Access Compliance Report

Public Rights-of-Way

(Curb Ramps)

Intersection ID: 43656	Main Street: HUNTINGTON_MEADOW_LN	Cross Street: CALLOW_FOREST_DR	Location: SE
ADA ID: E4991270B178	Ramp Type: Perp	Initial Pass/Fail: Fail	Overall Compliance: No
Severity Score: 10			
Codes/Mitigation Info/Possible Solution		Field Measurements/Component Compliance

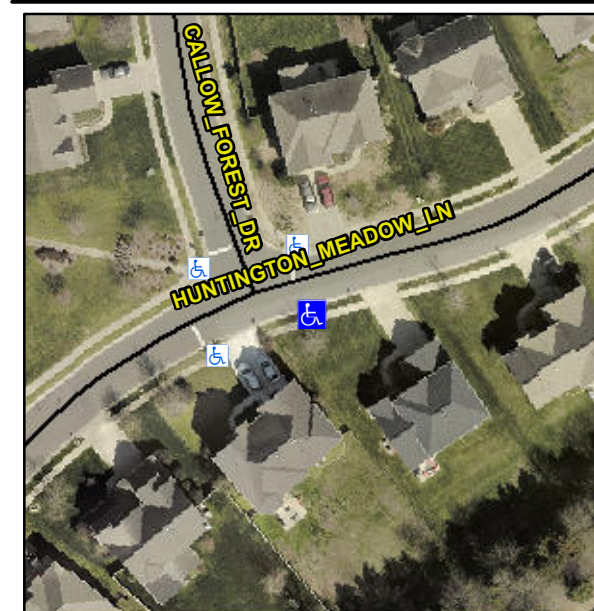
Not Found, R304.5.1, R304.5.3

Compliance	Description	Data	Compliance	Description	Data
N/A	Ramp Length (in)	47.0	Yes	Ramp Slope (%)	7.7
No	Ramp Width (in)	44.0	No	Ramp XSlope (%)	2.2
N/A	Flare Type LT	N/A	N/A	Flare Type RT	N/A
N/A	Flare Slope LT (%)	N/A	N/A	Flare Slope RT (%)	N/A
N/A	Flare Traversable LT?	N/A	N/A	Flare Traversable RT?	N/A
N/A	Landing Length (in)	N/A	N/A	DWS Provided?	N/A
N/A	Landing Width (in)	N/A	N/A	DWS Contrast?	N/A
N/A	Landing Slope (%)	N/A	N/A	DWS Length (in)	N/A
N/A	Landing X Slope (%)	N/A	N/A	DWS Full Width?	N/A
N/A	Landing Curb? (Y/N)	N/A	N/A	DWS Offset (in)	N/A
N/A	Shared Landing?	N/A			
N/A	Gutter Ponding?	N/A	N/A	Gutter Slope (%)	N/A
N/A	Gutter Lip Ht (in)	N/A	N/A	Gutter X Slope (%)	N/A
N/A	Painted X Walk1?	No	N/A	Painted X Walk2?	N/A
	X Walk 1 Direction	To N		X Walk 2 Direction	N/A
N/A	X Walk 1 Width (in)	N/A	N/A	X Walk 2 Width (in)	N/A
	X Walk 1 Slope (%)	4.2		X Walk 2 Slope (%)	N/A
	X Walk 1 X Slope (%)	1.5		X Walk 2 X Slope (%)	N/A

Remove & Replace Entire Ramp.
